Independent Technical Review of the X-740 Groundwater Remedy, Portsmouth, Ohio: Technical Evaluation and Recommendations

March 2010

Prepared for: The U.S. Department of Energy Office of Environmental Management
Groundwater and Soil Remediation Technology (EM32), Washington, DC

Prepared by: The DOE EM Center for Sustainable Groundwater and Soil Solutions,
Savannah River National Laboratory, Aiken SC

Figure 3. Summary conceptual model for TCE in the soil and groundwater in the vicinity of the former X-740 facility: a) simplified hydrology depicting flow directions and rates; b) contaminant distribution showing approximate geometry of the source and down gradient treatment targets

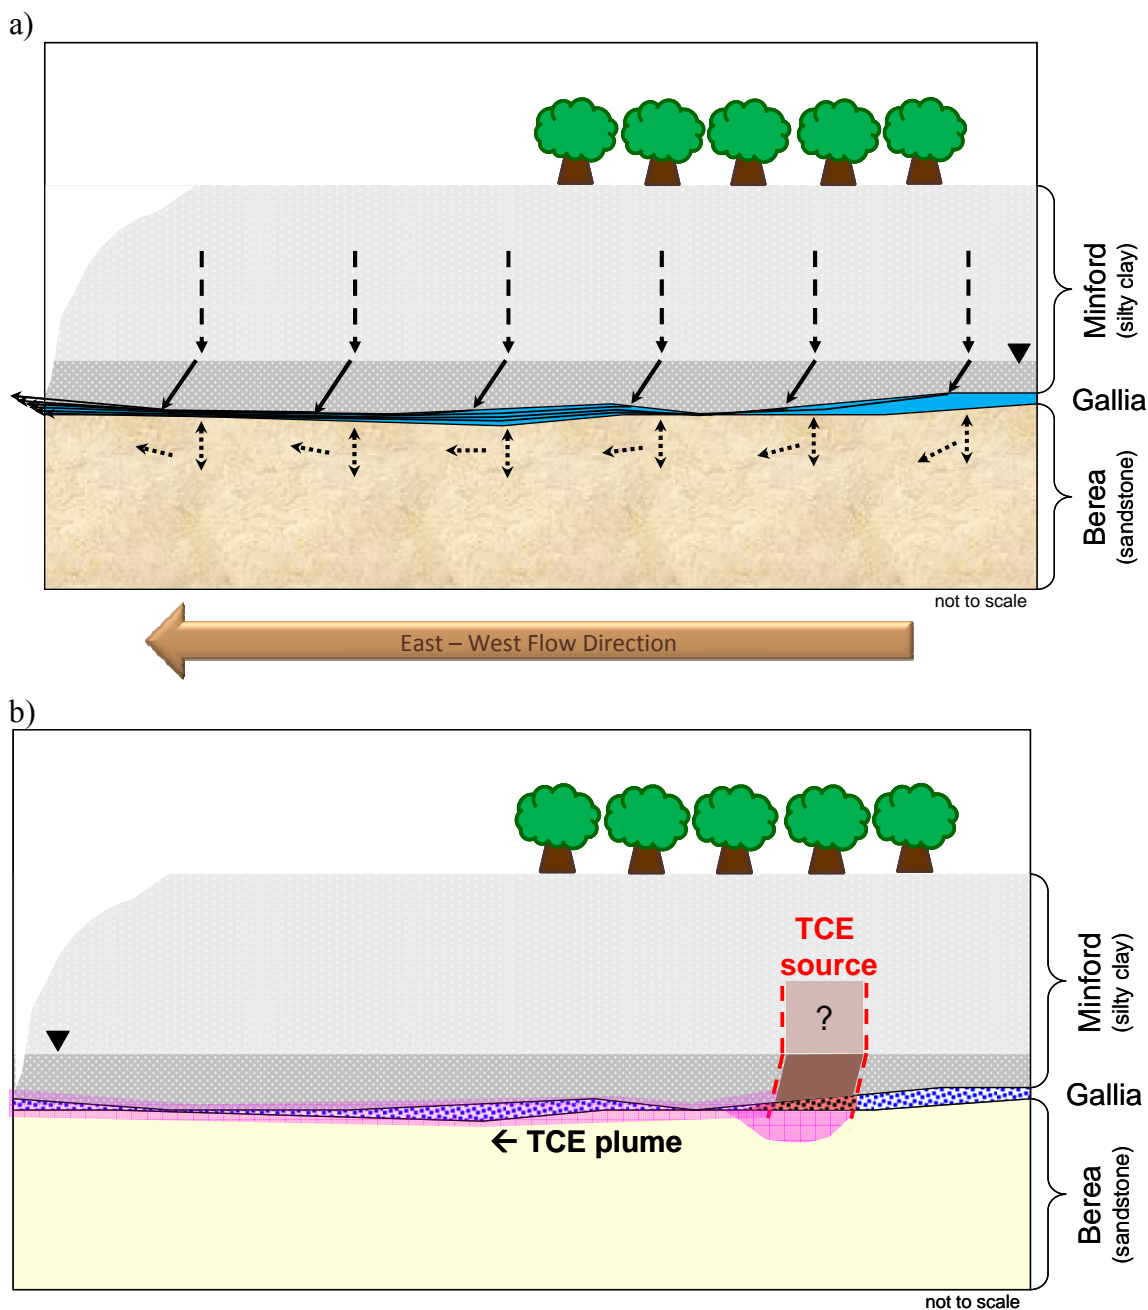
Consistent with the conceptual understanding of TCE contaminant hydrology at this site, the potential target treatment zones include (Figures 3a and 3b):

Of these target zones, the two Gallia treatment targets (2 and 3) are most accessible and amenable to treatment. The presence of contaminated low permeability zones above (Minford), below (Berea) and within the Gallia is an overarching challenge that strongly impacts the selection and design of potential remediation technologies. The slow release from less permeable Gallia sediments combined with inputs from contaminated portions of the “sandwiching” layers represent a long term source of TCE that can re-contaminate the Gallia in the future. Therefore, technologies that effectively treat the permeable portions of the Gallia, but do not leave residual treatment capacity in the system are unlikely to achieve long term remedial action objectives. Any technology selected for the groundwater source area should consider and address future TCE inputs from the Minford. Further, due to the dynamic relationship between the Gallia and the underlying Berea, technologies that reduce aqueous concentrations in the Gallia to relatively low level for an extended timeframe, should result in a steady reduction of the deeper zone concentrations and “shrinking” of the Berea plume. Finally, the distal catch basin and the associated piping appear to limit plume growth and are predicted to collect the groundwater from much of the TCE plume area.

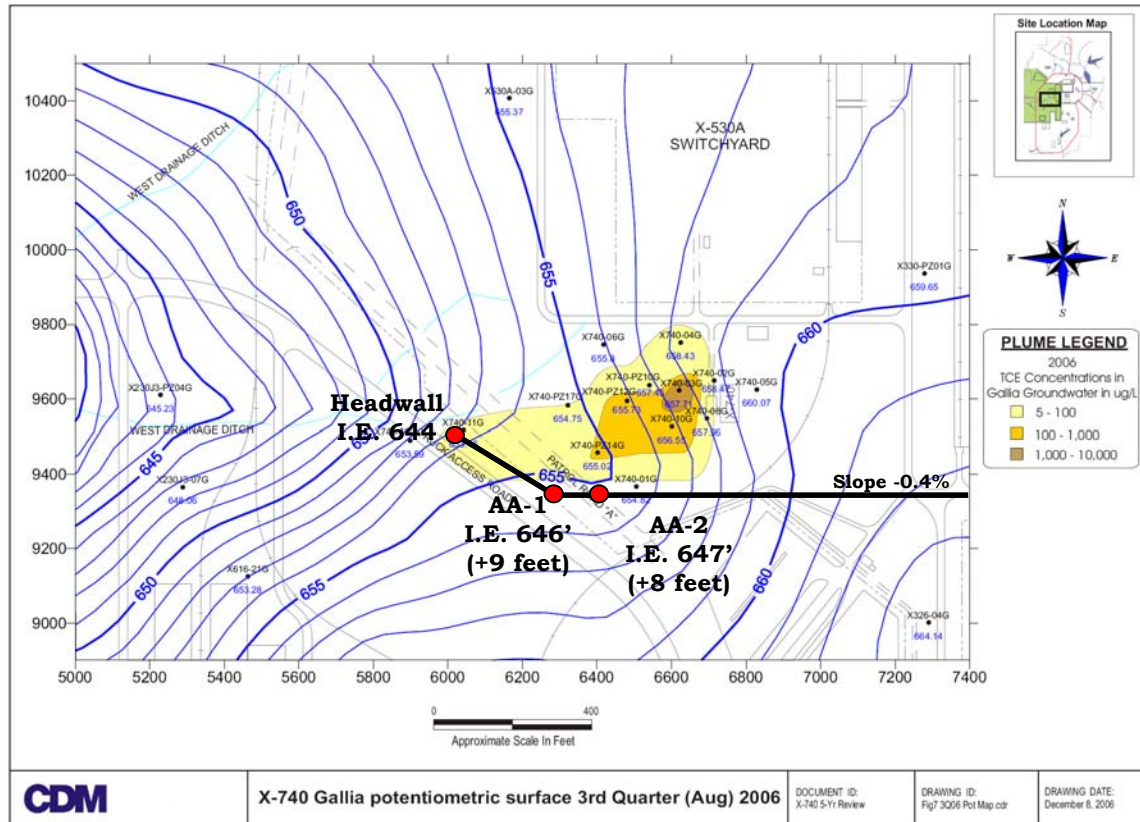
In the X-740 area, groundwater in the Gallia flows west toward site streams and a catch basin (“manhole”) and drain system (Figure 4). These hydraulic boundaries collect/drain water from the X-740 plume area. Significantly, the technical review team believes that the catch basin and the associated (“leaky”) concrete drain lines play a substantive role in limiting the growth of the plume – these distal drains “stabilize” the plume and provide infrastructure that might be usable as a component in future mitigation strategies. Because of their potential importance, the catch basin and related issues are addressed in more detail in the evaluation below.

The review team noted that water levels in the Gallia fluctuate significantly from season to season. Since the more conductive sediments in the Gallia function as the primary transmissive zone in this area, it provides the primary pathway that propagates the significant seasonal fluctuations in water level throughout the subsurface, and allows the overall hydrologic system to respond to changing boundary conditions. This concept suggests that TCE enters the low permeability (hydraulic conductivity approximately 0.5 feet/day) Berea by diffusion or by flow processes. Diffusion would contaminate a thin veneer of Berea adjacent to the Gallia plume. There are two types of flow driven processes: 1) resulting from regional flow patterns (depicted in Figure 3a as angled arrows in the Berea) and 2) resulting from seasonal oscillation in water levels (depicted in Figure 3a as oscillatory vertical arrows into/out of the Berea). In areas where the Gallia is contaminated, this latter process drives contamination into the Berea and then partially flushes it out according to seasonal cycles. Based on the data, TCE has penetrated the upper portion (approximately 10 ft) of the Berea.

Figure 8. Piezometric surface in the Gallia Formation near X-740.
a) "Baseline" and b) with a hypothetical upgradient passive drain

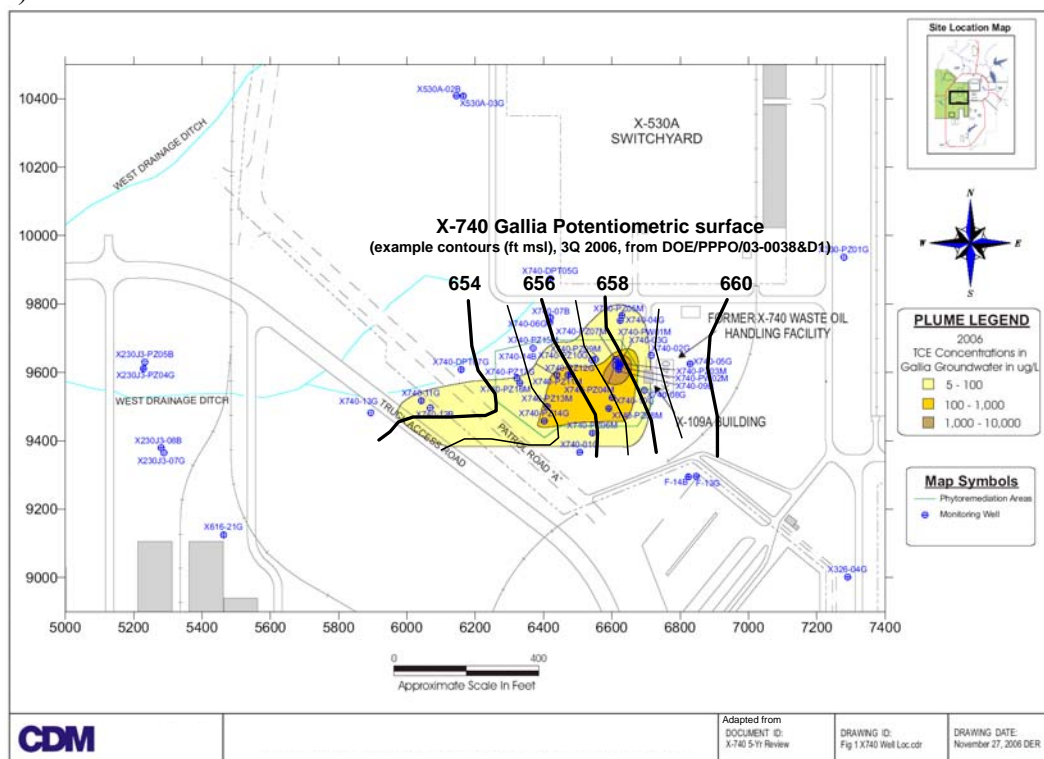
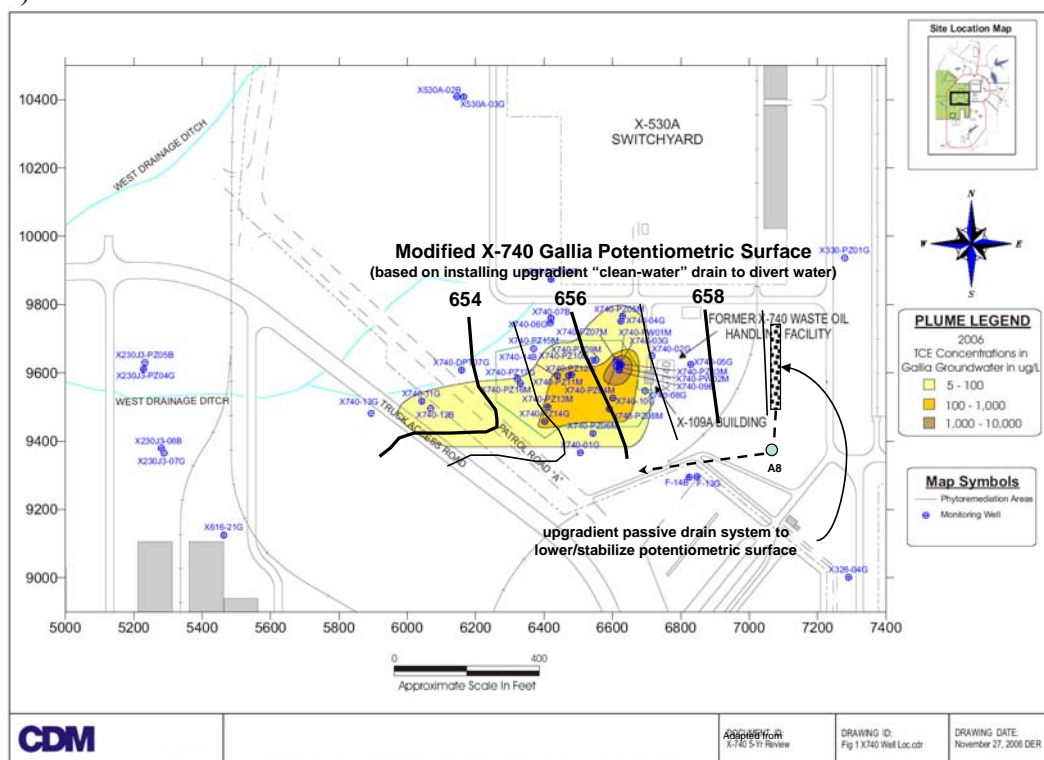
Passive hydraulic manipulation is a potentially effective and underutilized concept for isolating sources and reducing the flux and release of contaminants. In this case, “clean” water would be intercepted upgradient and passively diverted downgradient, reducing the flow of water through the source and plume. The result would be a reduction in contaminant release – each gallon of diverted clean water results in a concomitant reduction in the release of contaminated water. At some sites, this is a viable and attractive option because the flux-reduction benefits are realized without the need to treat any of the “clean” water being diverted. The hydrogeologic and engineering information provided for the X-740 site suggests a site specific opportunity for passive hydraulic containment. The Portsmouth engineering diagrams depict many large drain lines in subsurface in the vicinity of X-740 and that the elevation of these lines is often below the water table – in some cases, drain lines are located at depths that are in or near the Gallia and the piezometric surface in the Gallia is nominally 8 to 9 feet above the elevation of these drain lines. This infrastructure has the potential to serve, opportunistically, to support site remediation strategy. Specifically, our team identified that the catch basin (manhole) A-8 is located upgradient of the site. According to the engineering drawings, this catch basin is configured to accept an additional drain line and the system elevation may support installing a passive groundwater drain at minimal cost. The baseline and hypothetical passive drain piezometric surfaces in the Gallia are depicted in Figure 8, along with the location of catch basin A-8. Installation of the passive drain (Figure 8b) would reduce water flow through the contaminated area (exemplified by the more widely spaced contour lines), reduce the contaminant flux to downgradient stream and catch basin discharge boundaries, reduce the overall head (pressure) in the Gallia, and damp seasonal fluctuations in Gallia head. The “extracted” water would not contain TCE from the X-740 source or plume and should not require surface treatment. Thus, an upgradient

passive drain provides several potentially significant benefits, but the diversion of the water would also partially isolate and “stagnate” the plume in place and could extend the remediation timeframe. As a result, this strategy would be most useful if applied in combination with a primary treatment technology that would benefit from the reduced influx of upgradient water and the longer time that the contaminants would spend in the source zone and plume. An important example of such a primary technology is anaerobic bioremediation. The reduced inflow of water from upgradient would reduce the inflow of oxygen and other competing electron acceptors, would reduce the potential for flushing treatment reagent out of the target zone, and would allow more time for the induced bioremediation to degrade contaminants.

In summary, containment technology has potential value at the X-740 site. In general, this potential is limited if containment is used alone. Our review team supports the CDM alternatives evaluation report determinations that eliminated specific types of containment such as caps and walls and discouraged pump-and-treat. As described above, the review team urges the Portsmouth team to consider an upgradient passive drain strategy if it would couple synergistically with a primary treatment technology such as *in situ* bioremediation. This passive upgradient drain strategy was rated as viable and conditionally recommended.
